Request for Class II Permissive Change(C2PC)

FCC ID: VG8XM031MYYPV4

Please be notified that we, the undersigned, **Guangdong Midea Kitchen Appliances Manufacturing Co.,Ltd.** declare that the reasons for this class II permissive change are as below:

The original Grant Date is 03/22/2018.

1. Changed Mother -board as below.

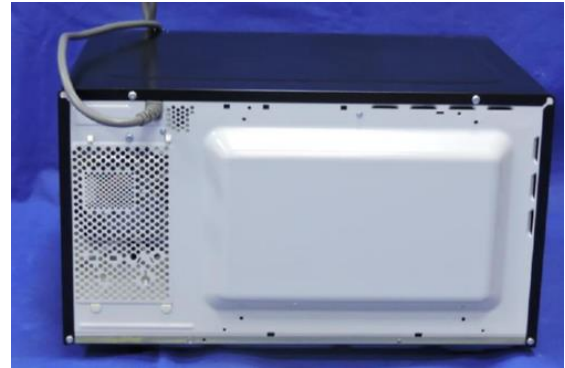
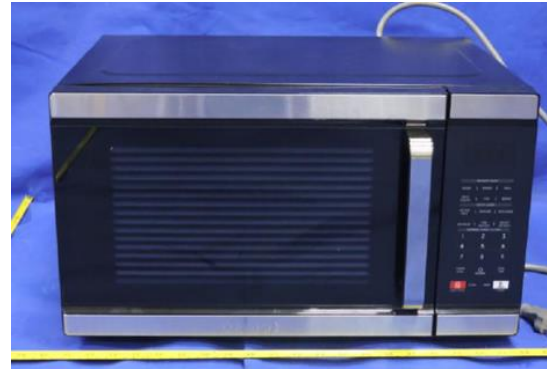
Part Name	The original	New	Differences
Mother board	No.: 17170000017203 Model : EMLAUSD-S1-K(F)	No.: 17170000027443 Model: EMLAA4P-S2-K(F)	1. PCB Layout different; 2. Switching power supply part: transformer base is increased, rectifier diode is changed to bridge reactor; 3. Local adjustment of humidity module, buzzer and other parts; 4. Mother board adds a LED display driver chip. Others are the same as before
